Nature of visit: Review odour controls.

Issues raised requiring written response:

Valspar Deeside

Site Plan 1:

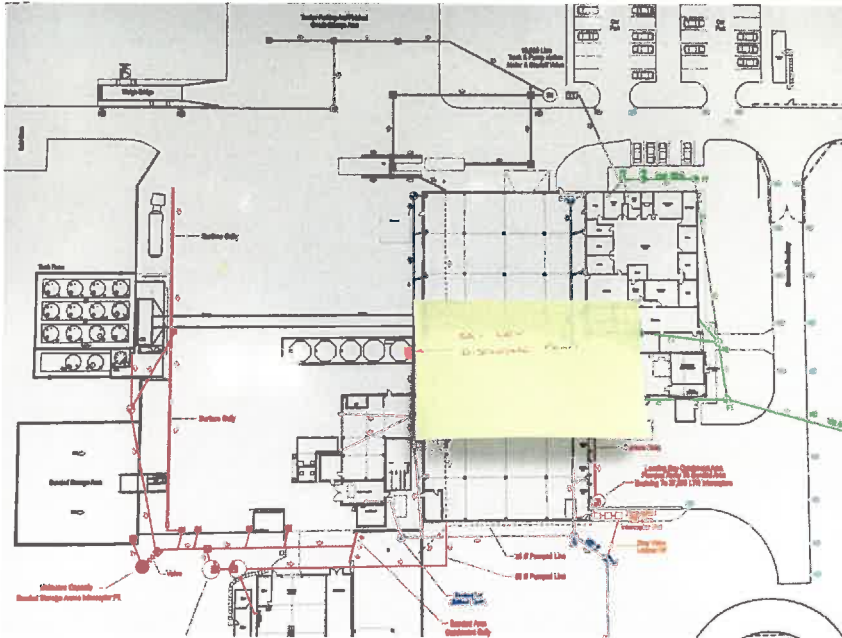
2. SA1 LEV discharge to air point

SA1 LEV was commissioned on the 28/11/2014 and is used to control exposure levels within the SA1 operating area and BP11 operating area within coatings. Refer to Photo 1 & Photo 2:

The SA1 external discharge point is shown on Site Plan 1 and Photo 3 & 4:

Site Plan 2:

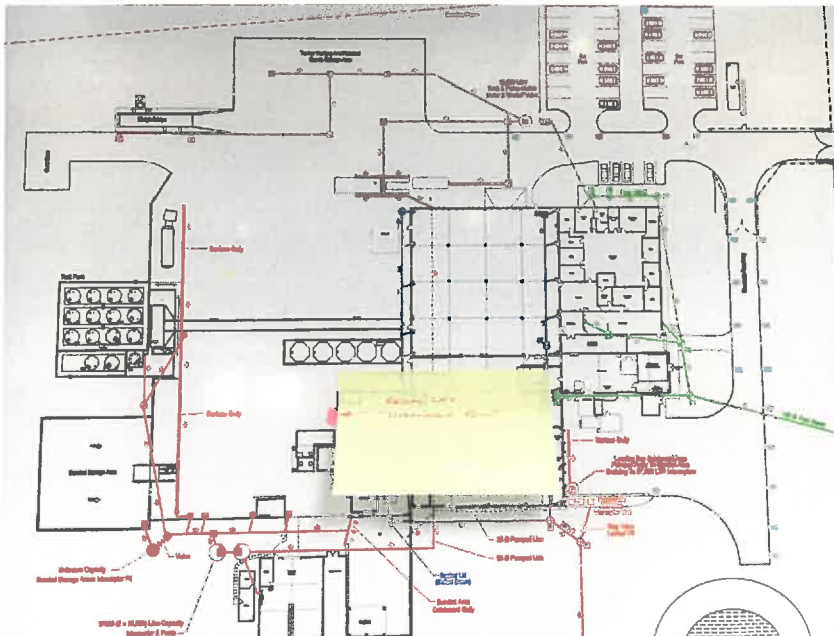
3. Resin TK Filters LEV discharge to air point

The Resin LEV unit was commissioned on the 28/11/2014 and is used to control exposure levels within the Resin TK Filters operating area. Refer to Photo 5:

Resin external discharge point is shown on Site Plan 2 and Photo 6:
